# Access Compliance Report

## Public Rights-of-Way

### (Curb Ramps)

Intersection ID: 9018	Main Street: GRANT_ST	Cross Street: LAKEWOOD_AV	Location: S
ADA ID: 5B580F24EBFF	Ramp Type: Perp	Initial Pass/Fail: Fail	Overall Compliance: No
Severity Score: 60			
Codes/Mitigation Info/Possible Solution		Field Measurements/Component Compliance

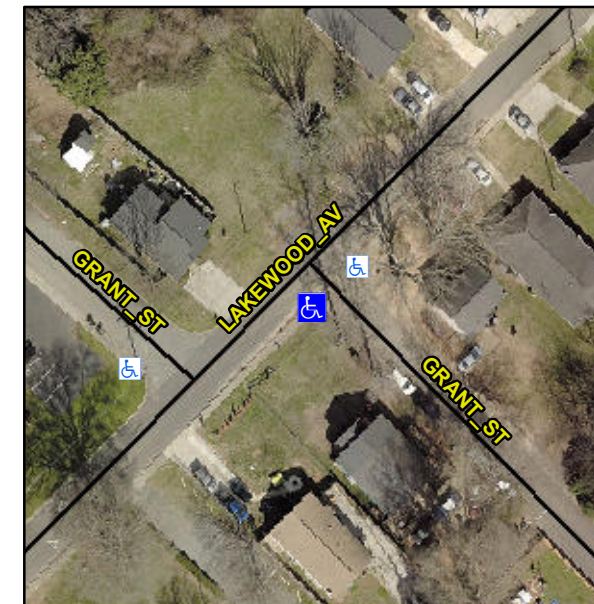
**R304.5.1, R304.2.2**

Compliance	Description	Data	Compliance	Description	Data
N/A	Ramp Length (in)	53.0	No	Ramp Slope (%)	12.2
No	Ramp Width (in)	27.0	Yes	Ramp XSlope (%)	0.1
N/A	Flare Type LT	N/A	N/A	Flare Type RT	N/A
N/A	Flare Slope LT (%)	N/A	N/A	Flare Slope RT (%)	N/A
N/A	Flare Traversable LT?	N/A	N/A	Flare Traversable RT?	N/A
N/A	Landing Length (in)	N/A	N/A	DWS Provided?	N/A
N/A	Landing Width (in)	N/A	N/A	DWS Contrast?	N/A
N/A	Landing Slope (%)	N/A	N/A	DWS Length (in)	N/A
N/A	Landing X Slope (%)	N/A	N/A	DWS Full Width?	N/A
N/A	Landing Curb? (Y/N)	N/A	N/A	DWS Offset (in)	N/A
N/A	Shared Landing?	N/A			
N/A	Gutter Ponding?	Yes	N/A	Gutter Slope (%)	N/A
N/A	Gutter Lip Ht (in)	N/A	N/A	Gutter X Slope (%)	N/A
N/A	Painted X Walk1?	No	N/A	Painted X Walk2?	N/A
	X Walk 1 Direction	To NE		X Walk 2 Direction	N/A
N/A	X Walk 1 Width (in)	N/A	N/A	X Walk 2 Width (in)	N/A
	X Walk 1 Slope (%)	3.7		X Walk 2 Slope (%)	N/A
	X Walk 1 X Slope (%)	1.2		X Walk 2 X Slope (%)	N/A

**Remove & Replace Entire Ramp.**
